Work Order ID 88720

Item Name: Crosstube Assembly, Mid Fwd

FIRST ARTICLE INSPECTION CHECKLIST

DRAWING NO. D206-667-147	TITLE CROSSTUBE ASS'Y (206L MID FWD)	REV. A	DART AEROSPACE LTD ENGINEERING ORDER		D.E.O. NO. D206-667-147-A-1	SHEET NO. SHEET 1 OF 1	SCALE NTS
DRAWN <i>q</i>	CHECKED <i>ASS</i>	MFG. APPR. <i>JB</i>	APPROVED <i>MD</i>		DE APPR. <i>MD</i>		
DATE 11.07.15	DATE 11.07.20	DATE 11.07.21	DATE 11.07.21		DATE 11.07.21

DART AEROSPACE LTD	Work Order:	<i>2872e</i>
Description: Crosstube Assembly, Mid Fwd	Part Number:	D206-667-147TRN
Inspection Dwg: D206-667-147 Rev: A		Page 2 of 2

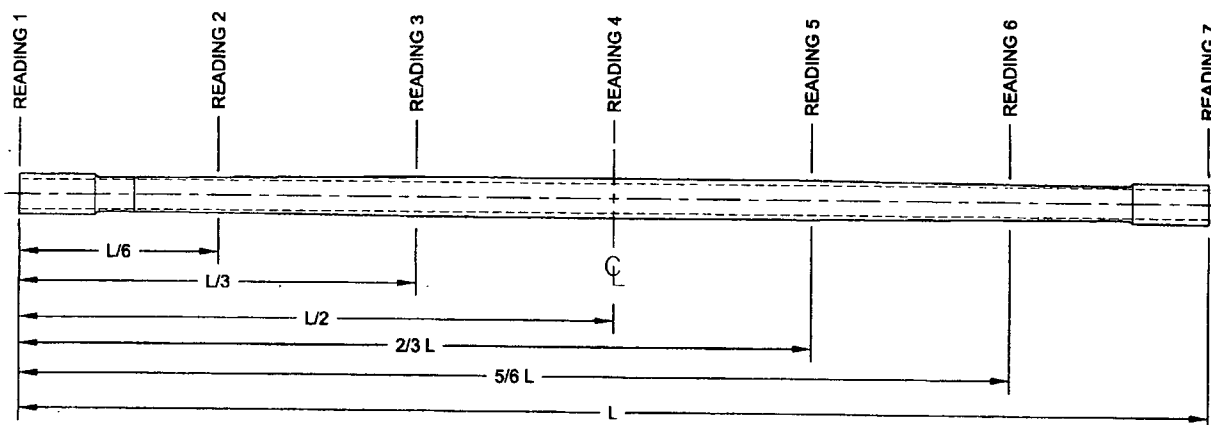
Cuff out of tol.
(taper/quality)

2.242" - 2.236"

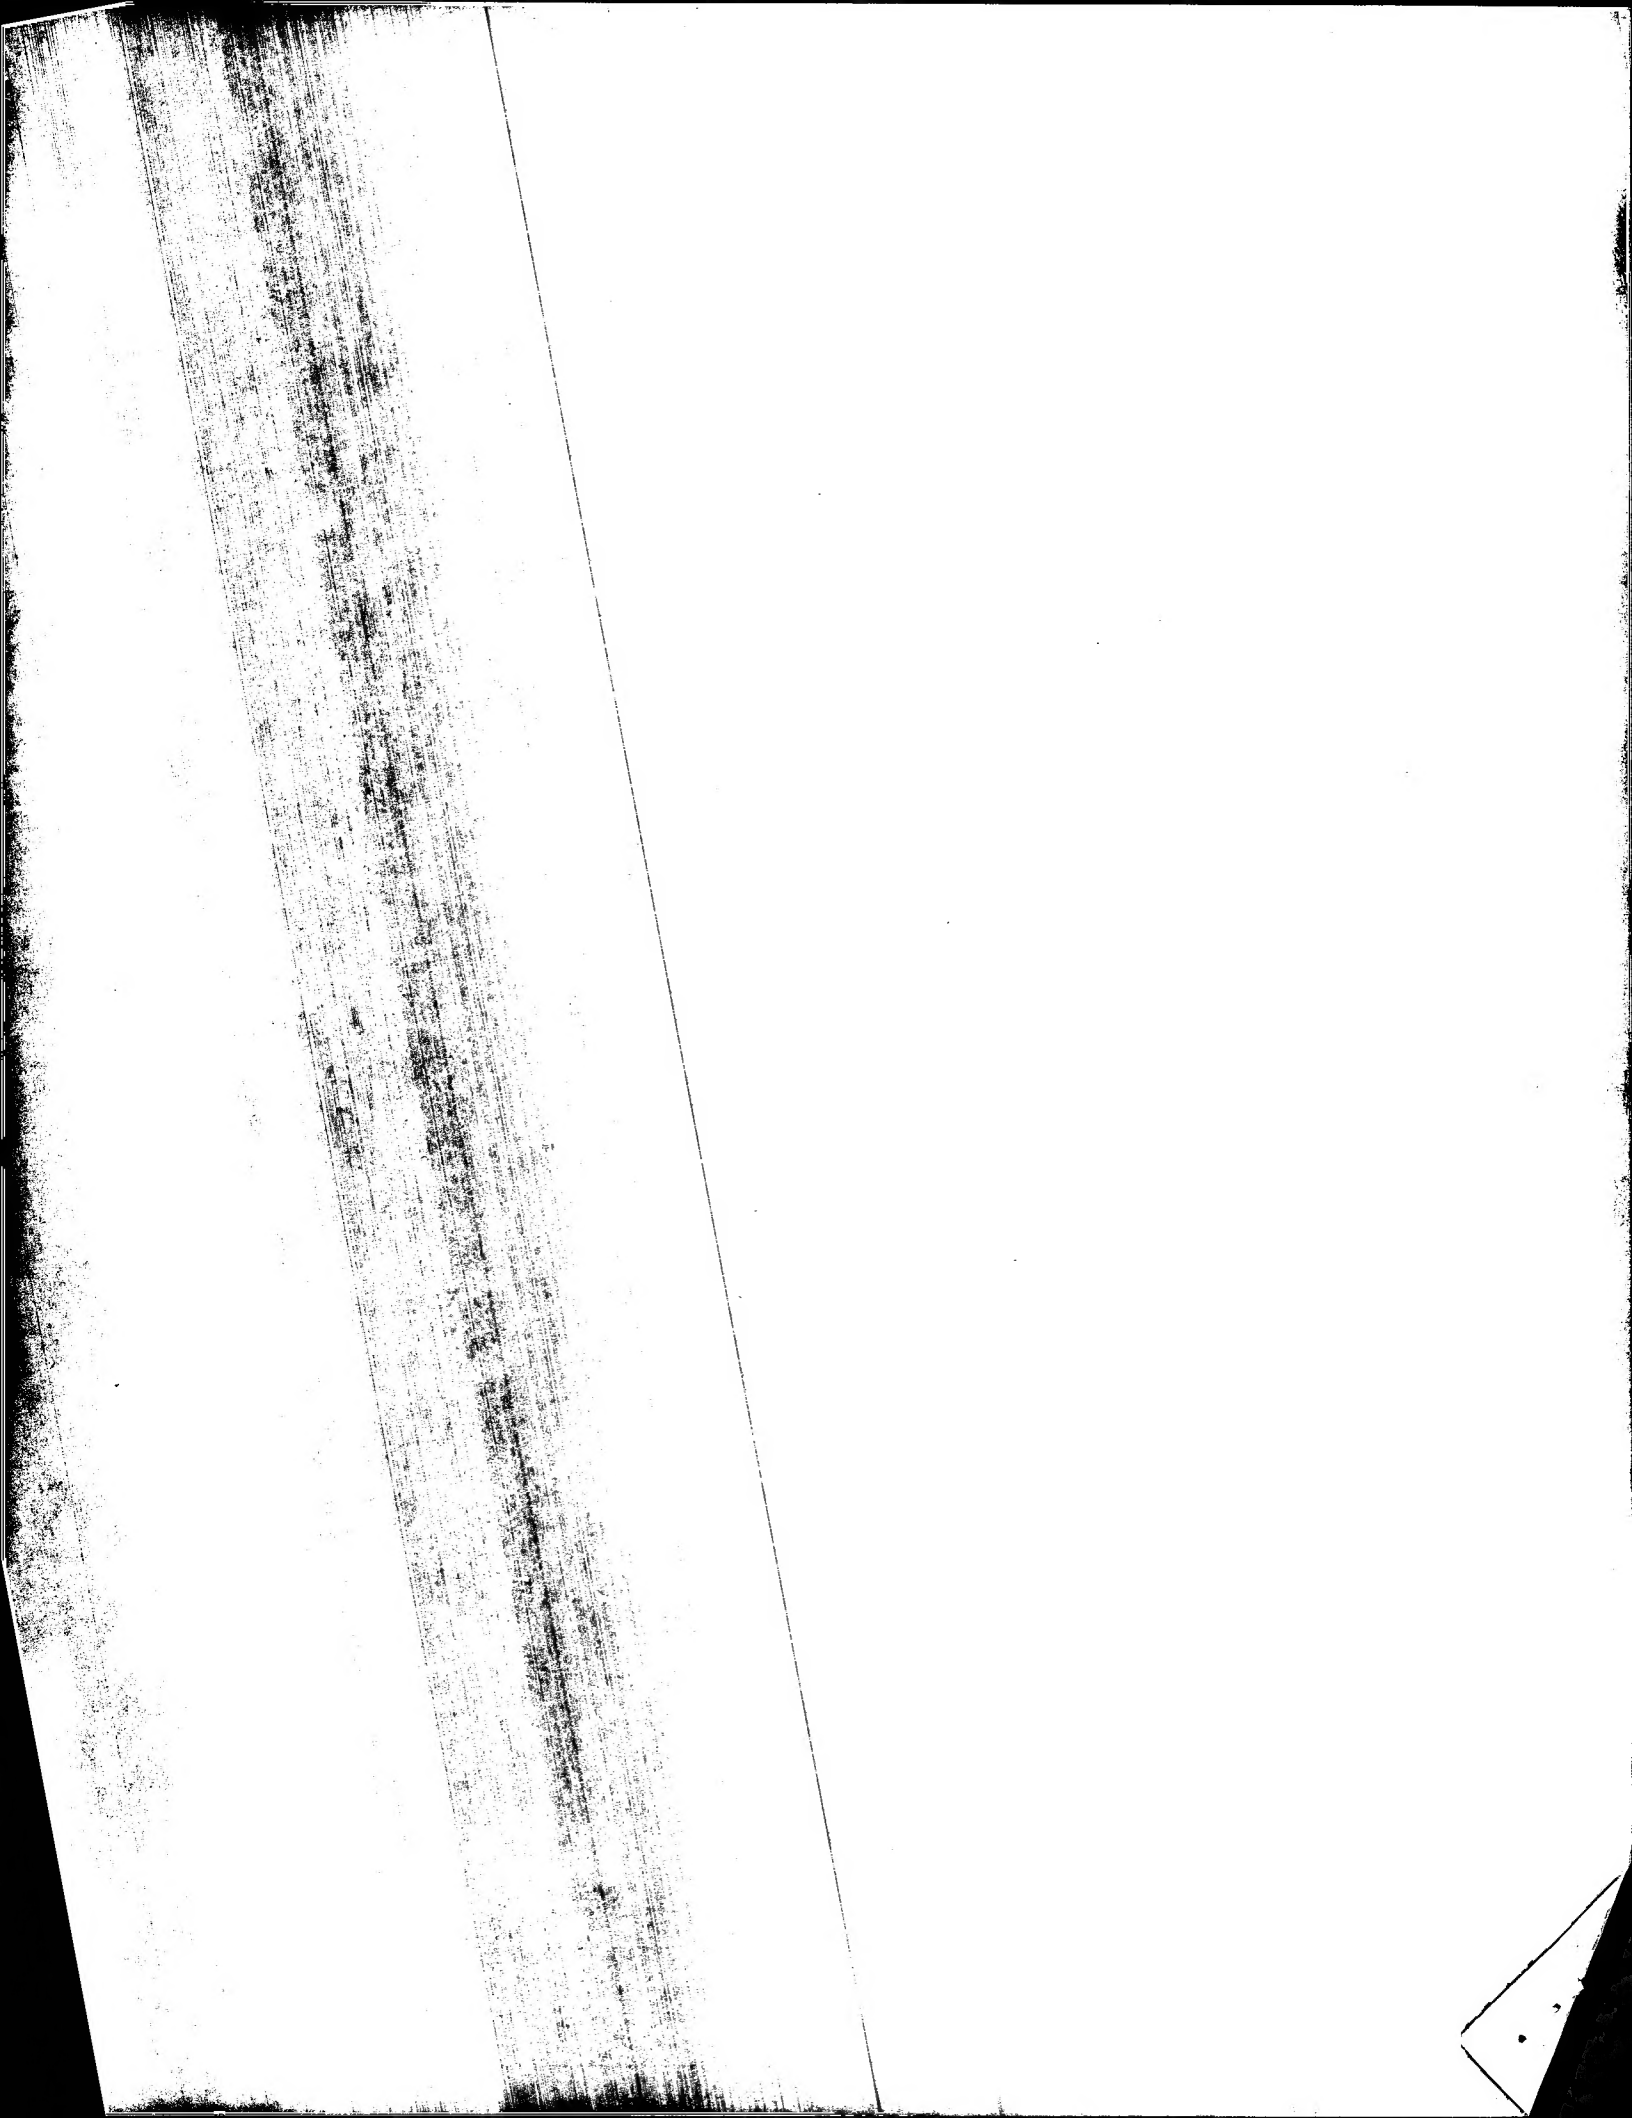
PURPOSE:

REPLACE MAGNOBOND WITH PROSEAL.

NOTE 12 & 15, SHEET 1 IS AMENDED AS FOLLOWS:

Item	Qty -147	Part Number	Description
9	A/R	PROSEAL 890 B-2	SEALANT, AMS-S-8802 CLASS B-2

- 12) TO INSTALL D2891-1 SUPPORT: ABRABE MATING SURFACE OF SUPPORT AND CROSSTUBE WITH 180-GRIT SANDPAPER AND REMOVE RESIDUE WITH MEK (OR EQUIVALENT). APPLY A 0.04" TO 0.07" THICK LAYER OF PROSEAL 890 CLASS B-2 (OR AMS-S-8802 CLASS B-2) SEALANT TO MATING SURFACE OF SUPPORT.
- 15) TORQUE CLAMPS 80 TO 100 IN-LB. ENSURE AT LEAST 1.5 THREADS SHOWING IN SAFETY AND THAT NUT HAS NOT BOTTOMED-OUT AFTER TORQUING. **PRIOR TO PACKAGING, RE-CHECK TORQUE ON CLAMPS AFTER PROSEAL 890 SEALANT HAS CURED FOR 72 HOURS.**
